# STREAM AND WETLAND ECOLOGICAL ENHANCEMENT PROGRAM (SWEEP) ISSUE TASK FORCE (ITF) MEETING MINUTES

I-70 Floyd Hill to Veterans Memorial Tunnels

Project:	I-70 Floyd Hill to VMT
Meeting:	SWEEP Issues Task Force Meeting
Date:	April 17, 2018; 1:00 pm to 3:00 pm
Location:	CDOT Region 1, 425 Corporate Circle, Golden, CO

**Project:** I-70 Floyd Hill to Veterans Memorial Tunnels NEPA and 30% Design Meeting: 21912 Floyd Hill SWEEP #2 Date: October 25, 2018 CDOT Golden Region 1, Lookout Mountain Location:

# PROPOSED SEDIMENT CONTROL LAYOUT

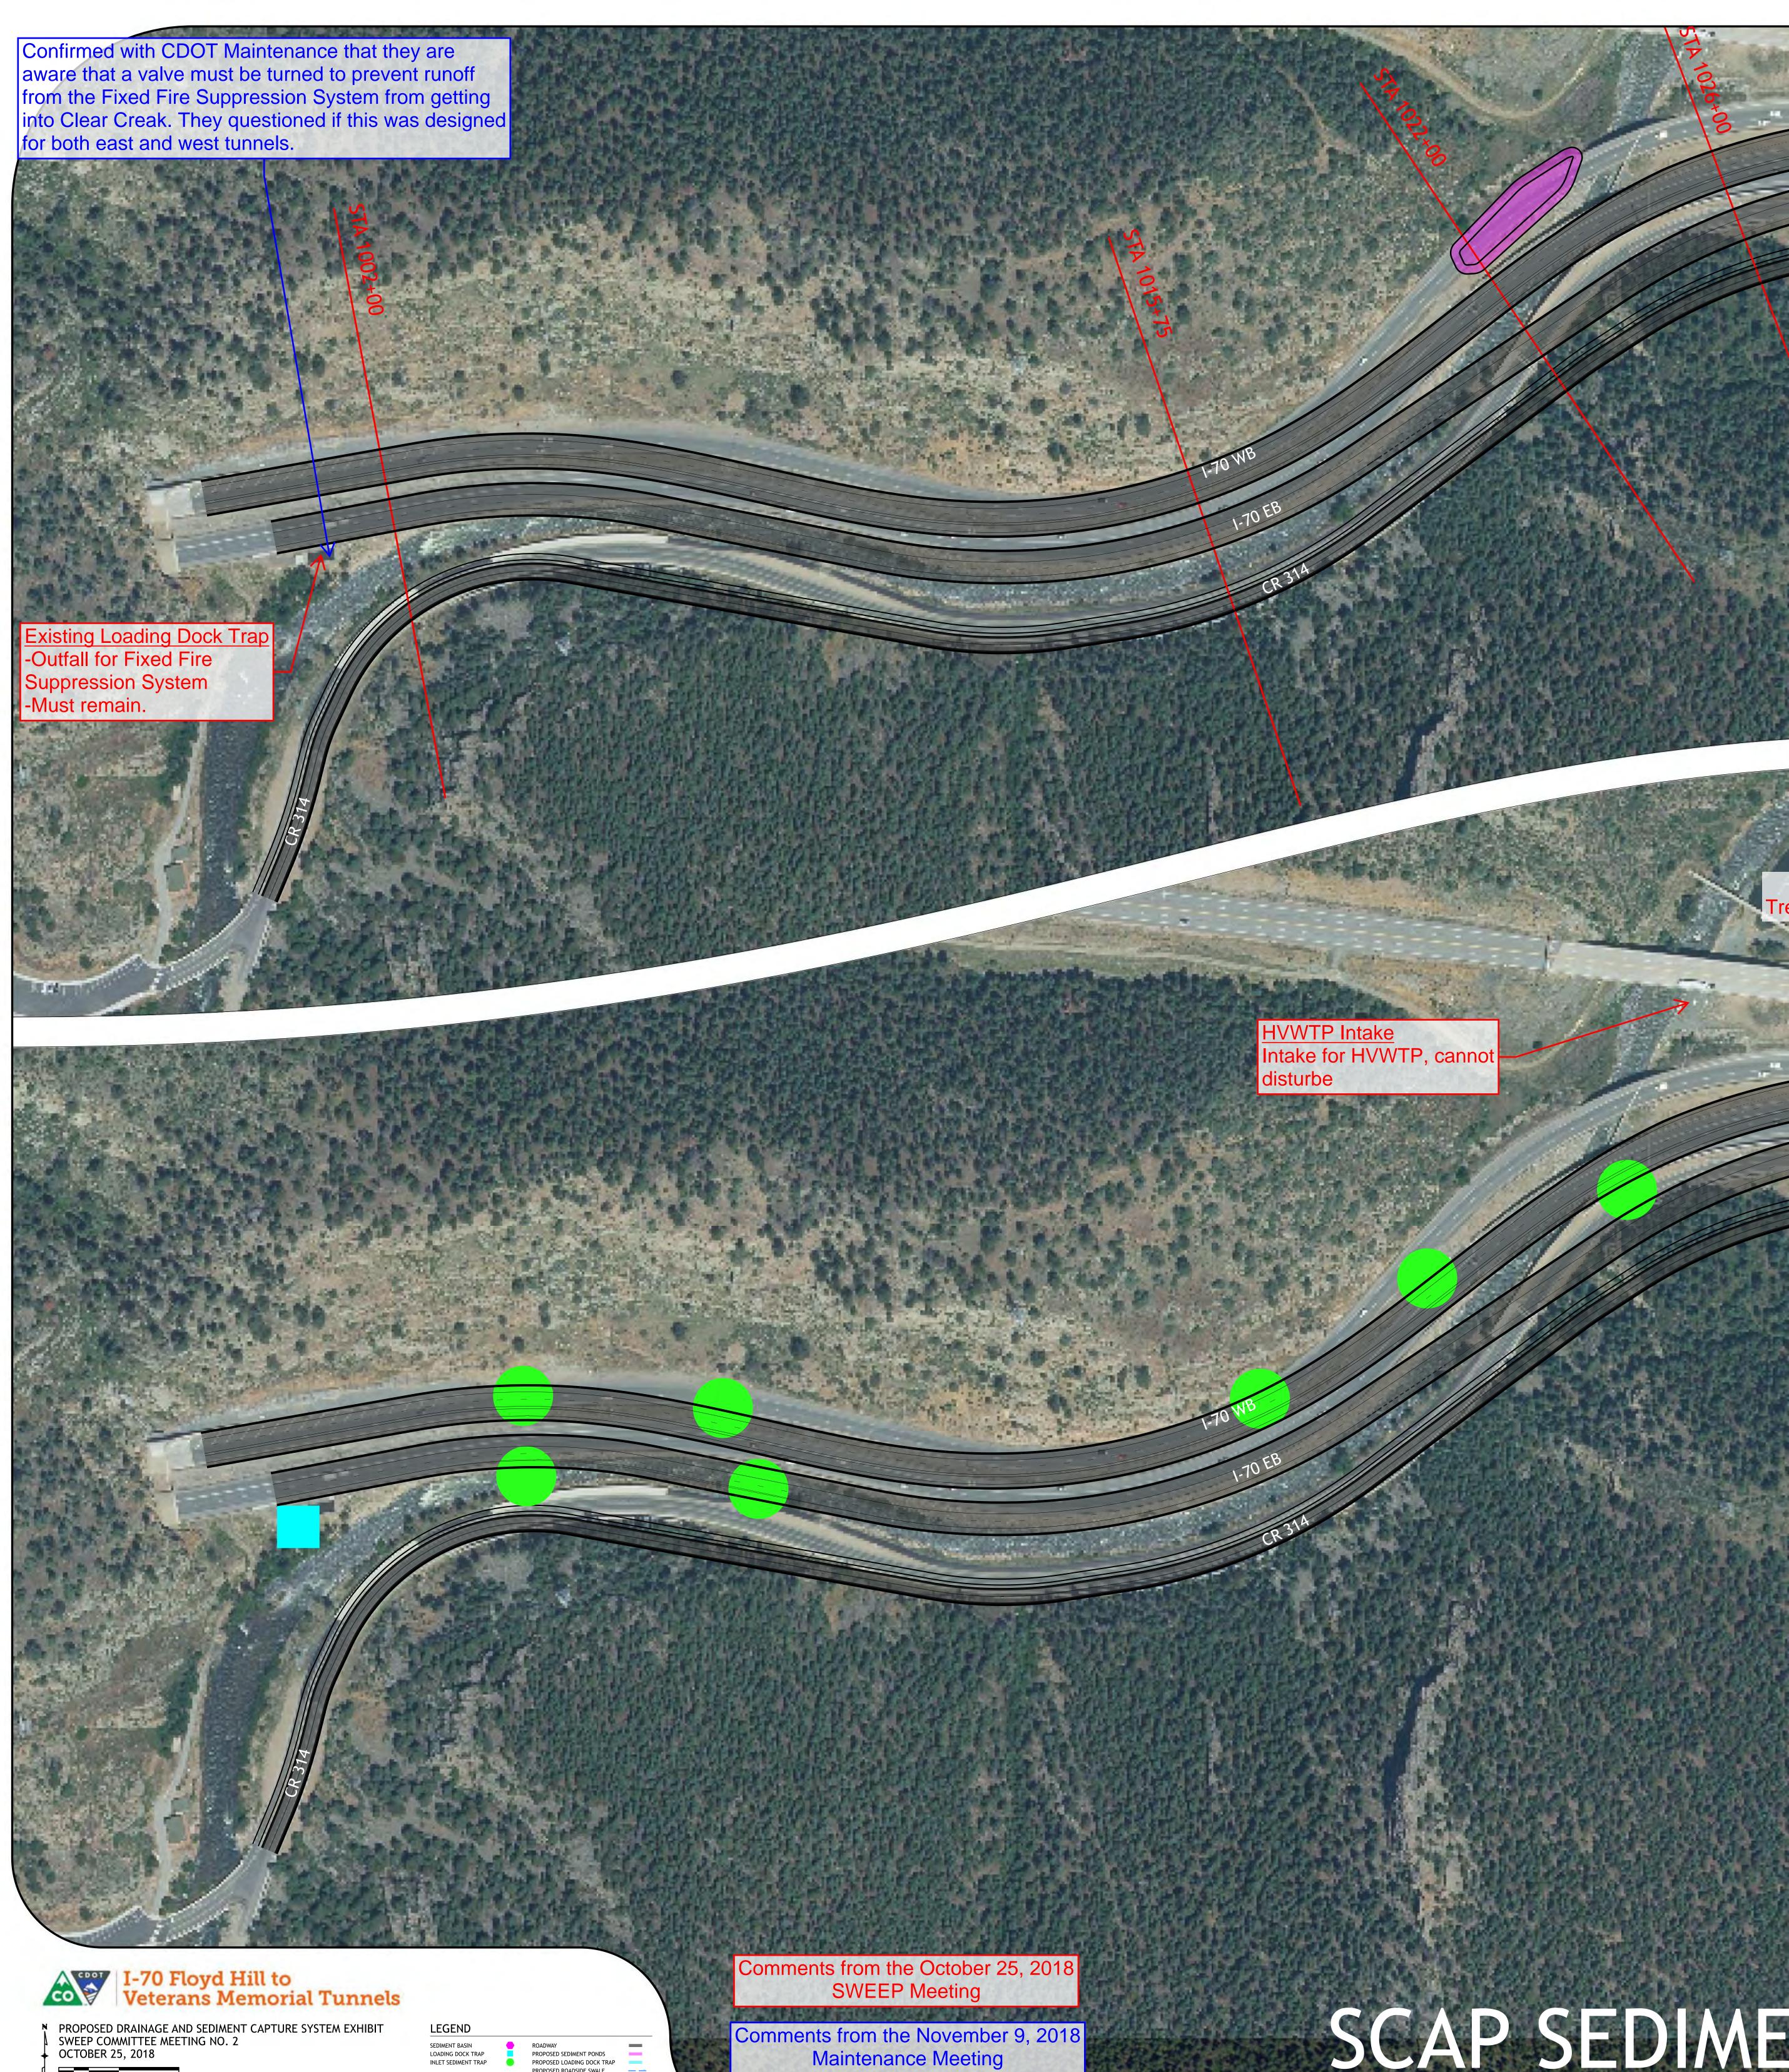
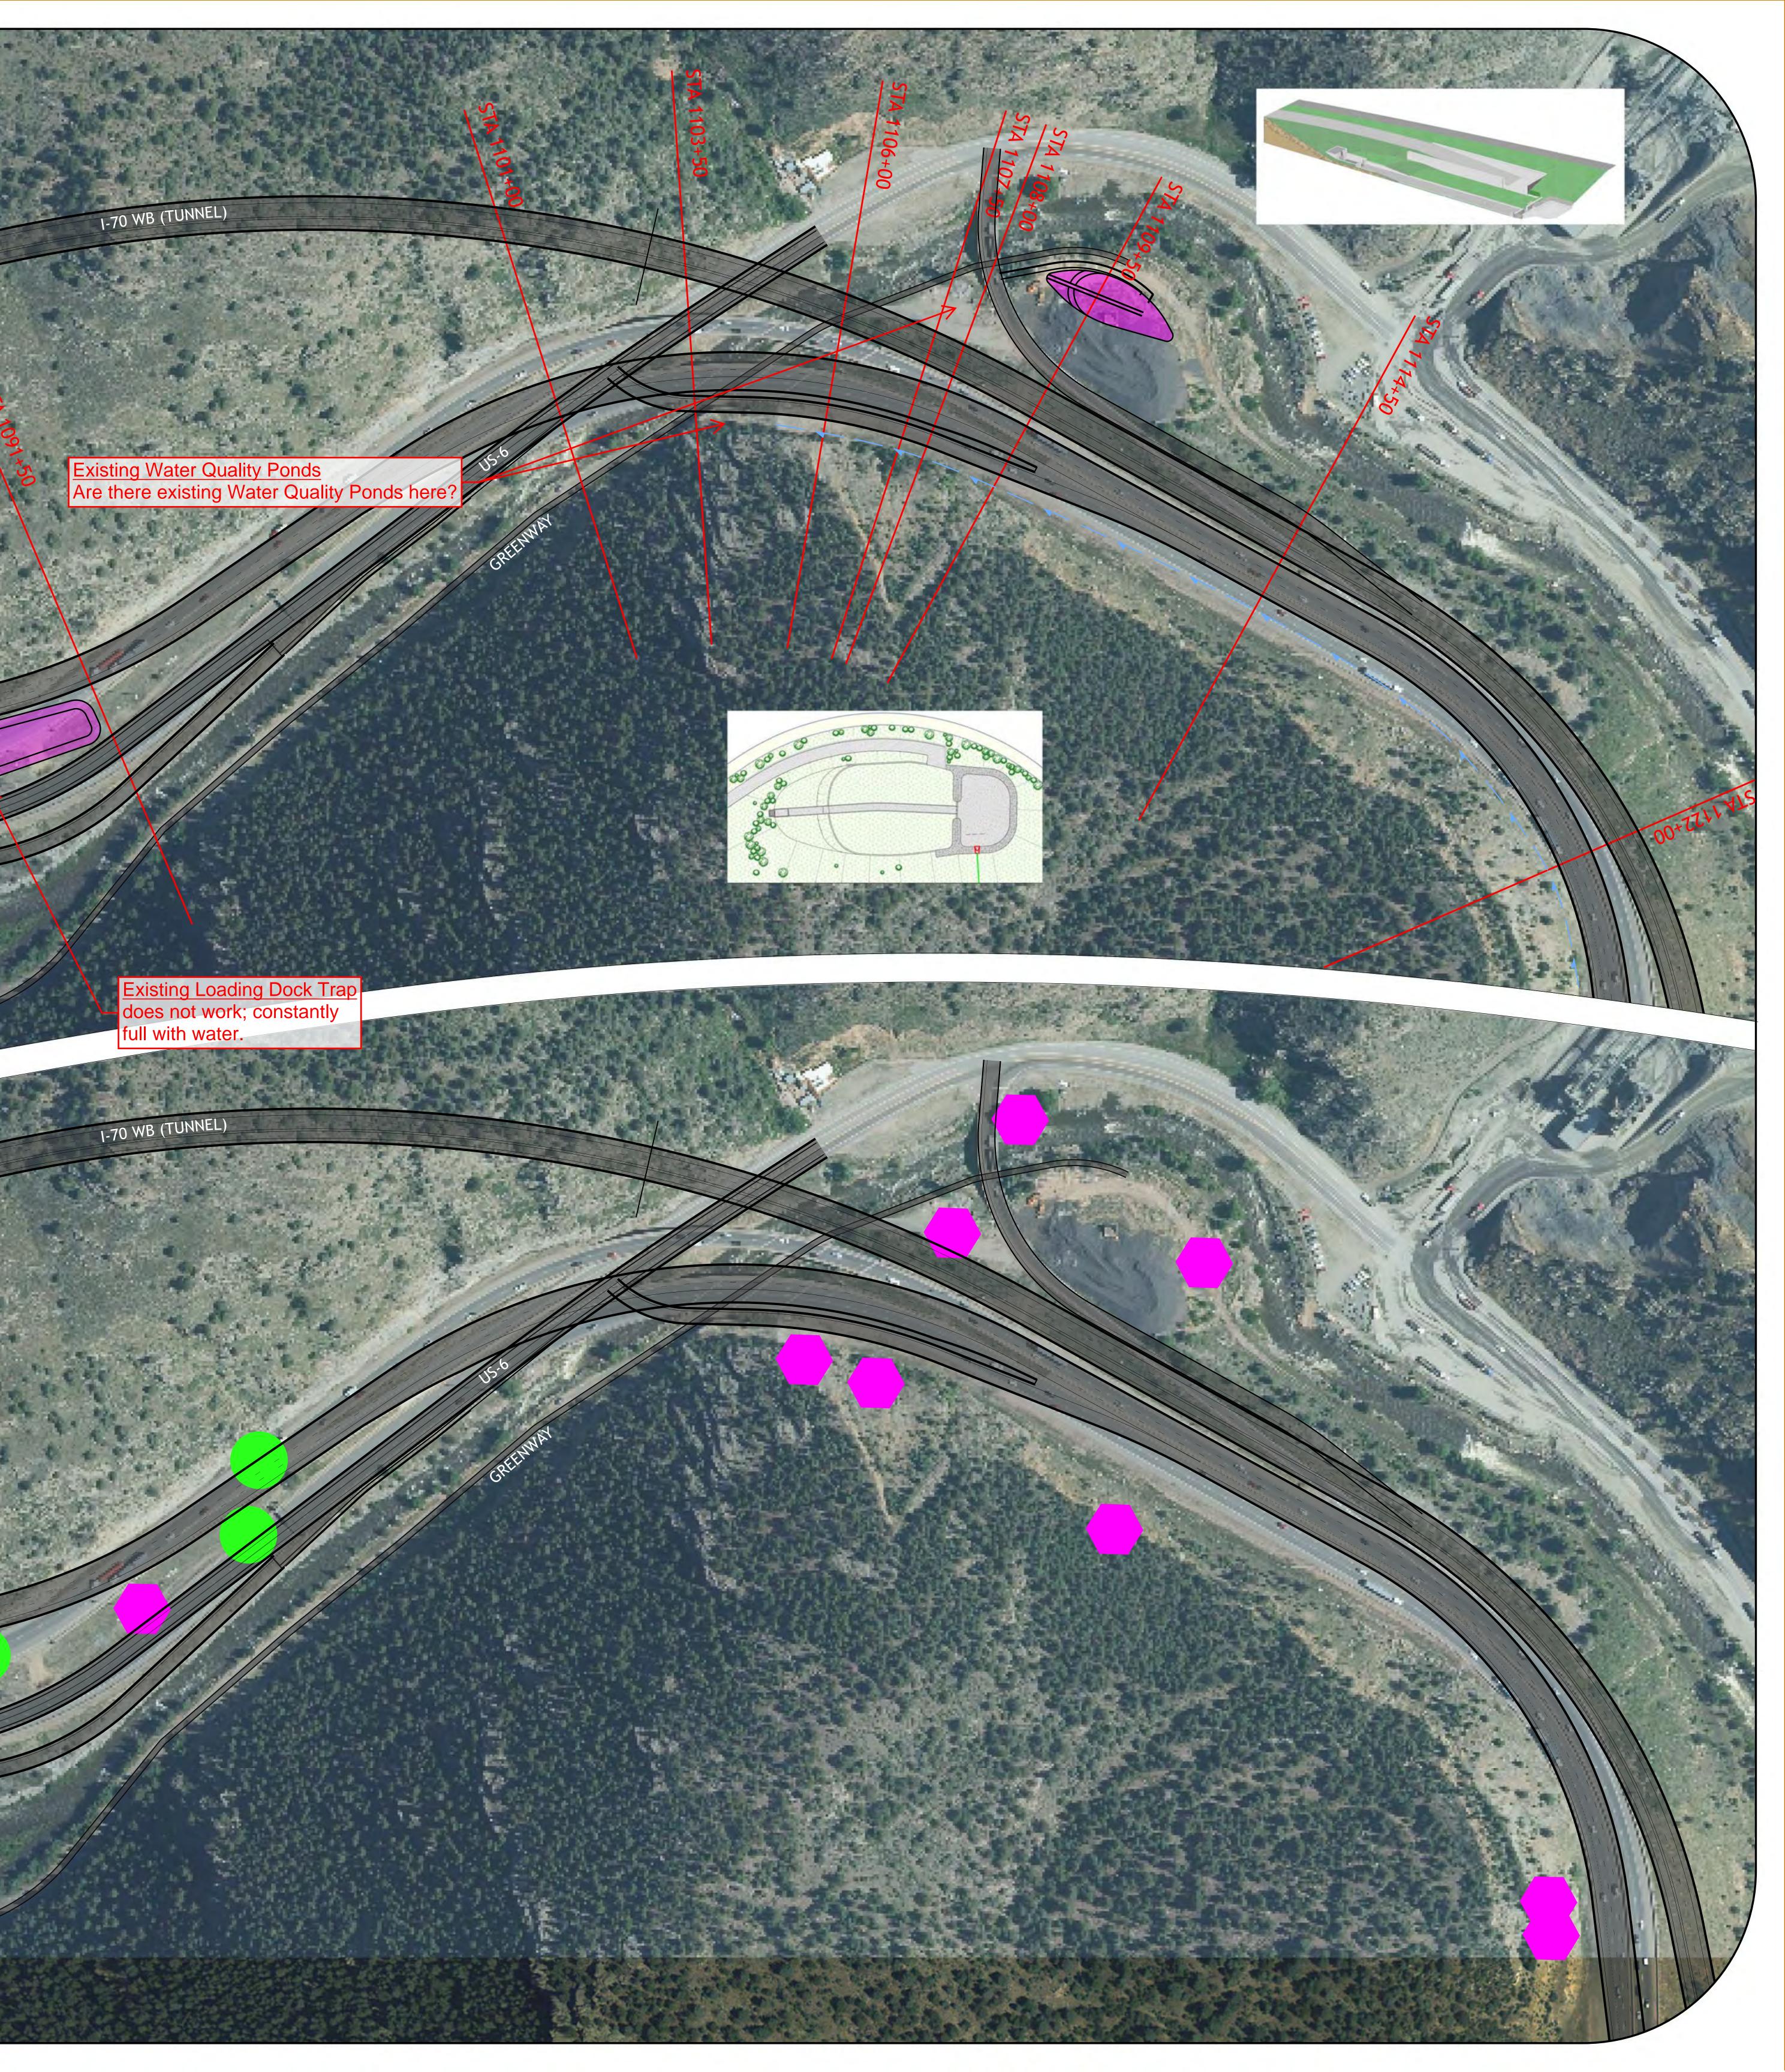
- (ii) Jo Ann Sorenson receives annual reports on the sediment basins from the EB PPSL project that show the structures are not capturing sediment. Need to design them so that they work. Based on discussions with Maintenance after the meeting, the lack of sediment may also be due to the lack of sand use in the area.

- ii) Sediment Basins:
  - a) 27 shown in the SCAP
  - b) 12 Proposed with the Project design
- iii) Roadside Swales
  - a) Proposed with the Project due to limited right-of-way and trying to limit the Project's disturbed area.
  - b) The swales will provide some treatment of runoff prior to being discharged into Clear Creek
- iv) Loading Dock Traps:
  - a) 3 shown in the SCAP
  - b) 1 proposed with the Project because there is no room for a sediment basin in that area.
  - c) The location is not in a highly visible area based on the current proposed design and the design will ensure that it is as minimally visible as possible
- v) Inlet Sediment Traps:
  - a) 26 in the SCAP
  - b) None proposed for the Project
  - c) Dangerous and difficult to maintain because Maintenance has to do lane closures at night to clean them
  - d) Not effective because they are not maintained

- c) Recommended communication and hand off; provide a map of BMPs to:
  - i) Maintenance
  - ii) Fire response
- d) Design considerations/review:
  - Station 1022+00: Capture area (tunnel to bridge) sediment basin is just upstream of the intake: Proposed design must not impact or modify the existing water intake for the Black Hawk water treatment facility

- (a) Approximate location is north of the highway and may be in between I-70 and Central City Pkwy to the west of the treatment plant
      - (b) Need to coordinate with Central City because this location is one of their PWQ features
